Remodel of existing retail space into a new branch for America First Credit Union

FORM P3: ADMINISTRATIVE DECISIONS AND MINOR AMENDMENTS

Proposed site revision for the America First Credit Union tenant improvement. Remove portion of existing storefront windows and add a walk-up ATM to the existing exterior wall.

AFCU - ALBUQUERQUE BRANCH
 3400 HIGHWAY 528
 ALBUQUERQUE, NM

EXTERIOR ELEVATIONS

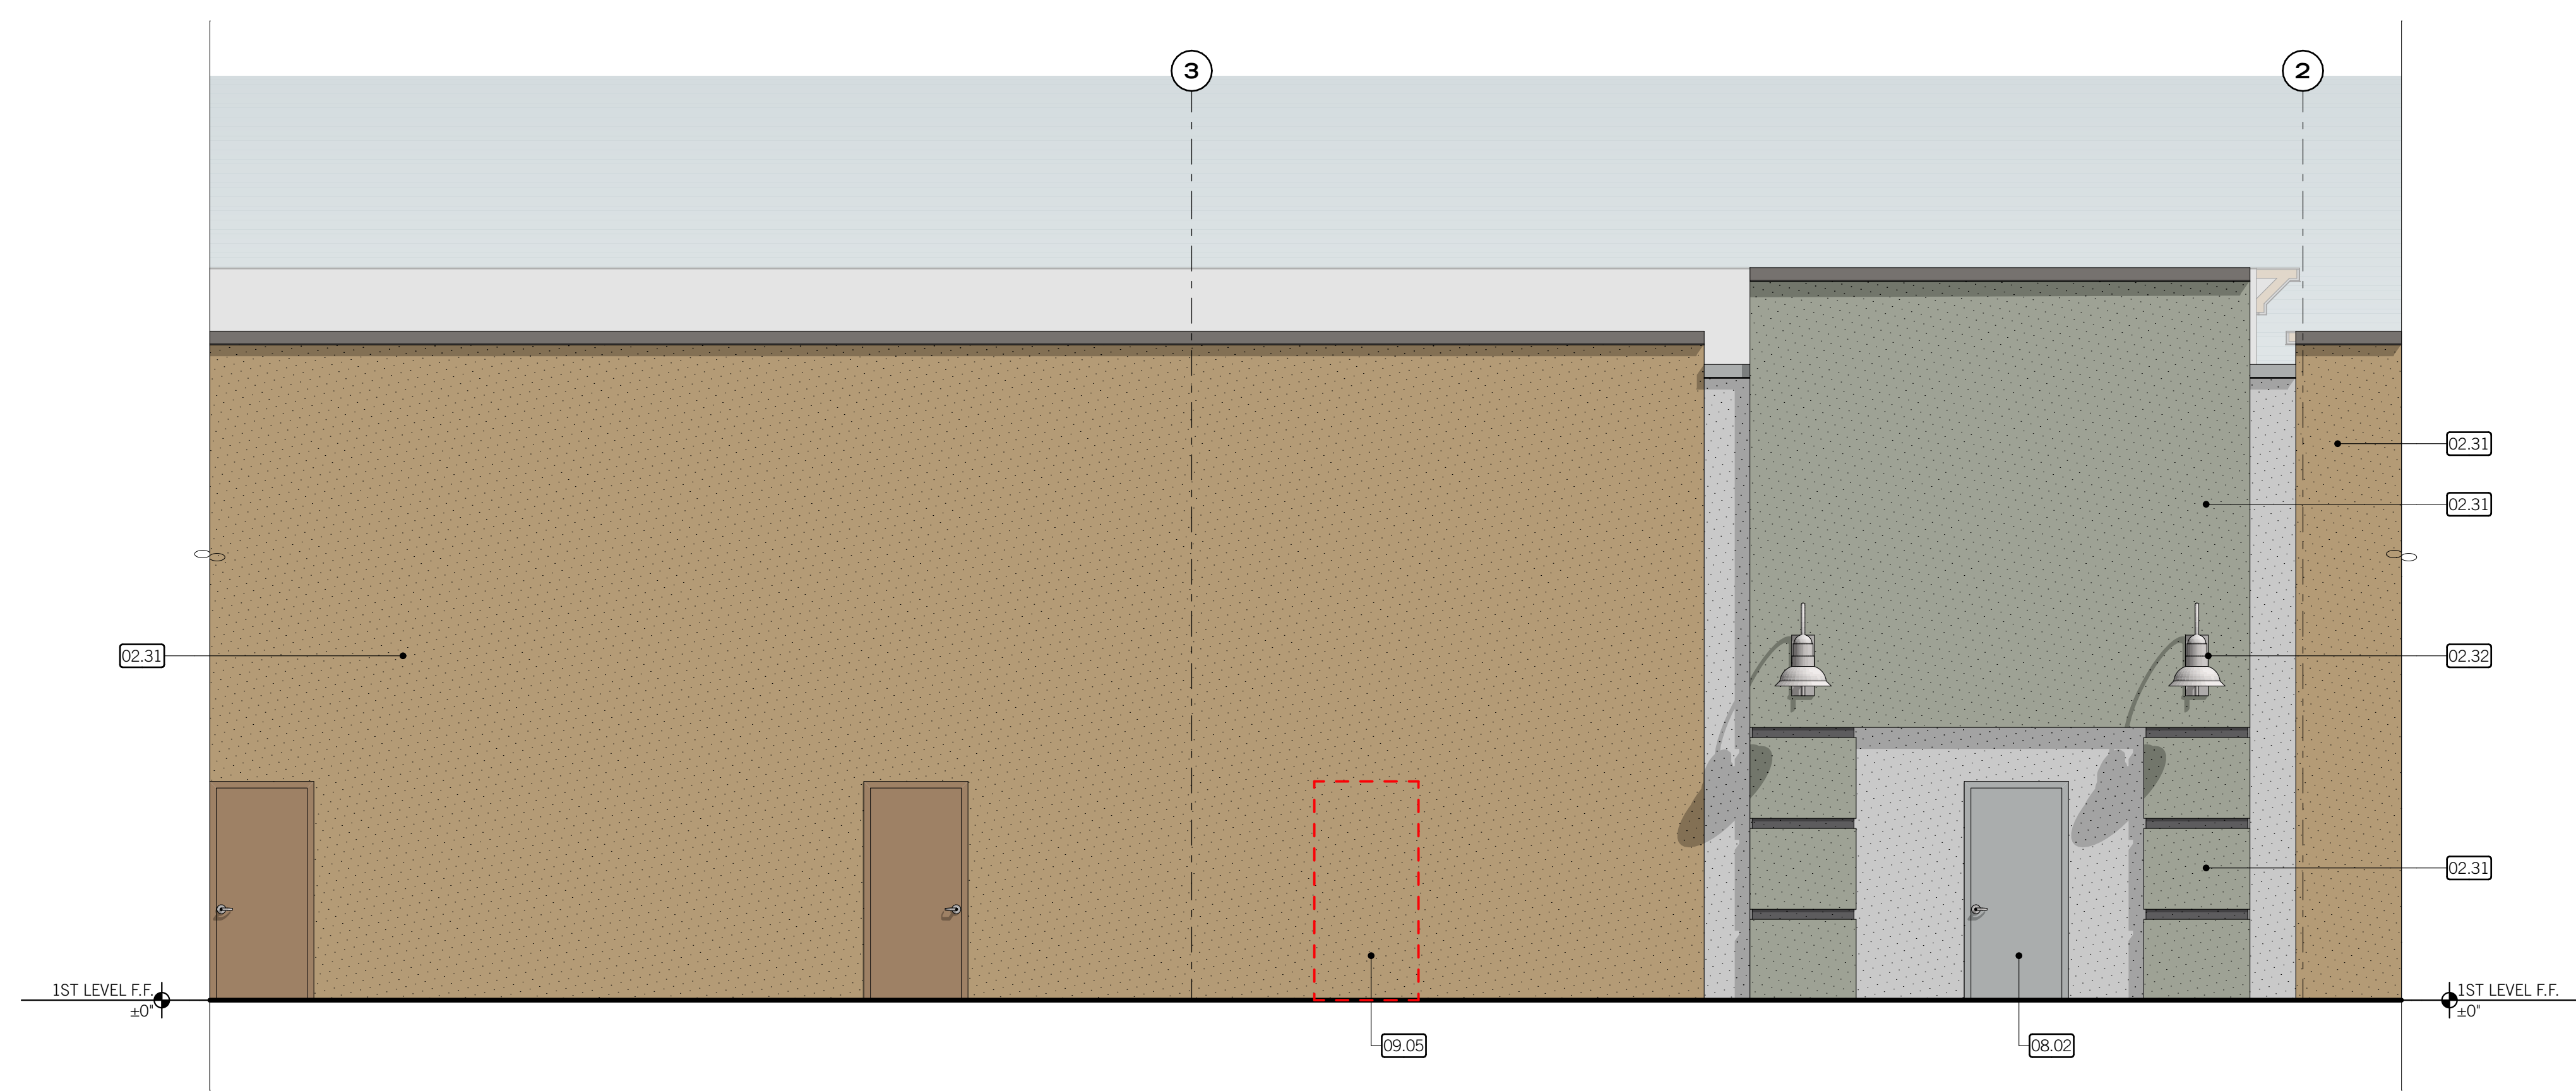
- 09.05 Infill existing wood framed exterior partition with wood framing and batt insulation to match existing at location of demolished storefront/hollow metal door system. Install 5/8" gypsum board at inside face of wall to match existing. Skim coat wall to provide smooth level finish - paint. Install plywood wall sheathing and exterior EIFS system to match existing @ exterior. Paint existing EIFS adjacent to existing storefront opening to match new EIFS.

- 09.18 Infill existing wood framed exterior partition with wood framing and batt insulation to match existing at location of demolished storefront system. Install 5/8" gypsum board at inside face of wall to match existing. Skim coat wall to provide smooth level finish - paint. Install plywood wall sheathing and exterior EIFS system to match existing @ exterior - re: exterior elevations. Coordinate opening dimensions with ATM supplier. Install stainless steel flashing around ATM wall opening where occurs. Paint existing EIFS adjacent to existing storefront opening to match new EIFS. Re: detail 06A1.2.

- 10.05 Building mounted exterior sign by Owner. Provide electrical power as per electrical drawings.
- 11.08 ATM machine (N.I.C.) - provided by Owner's Equipment Contractor - re: equipment plan. Coordinate rough opening dimensions in exterior wall with Owner's Equipment Contractor. Re: detail 06A1.2 for stainless steel flashing at opening.
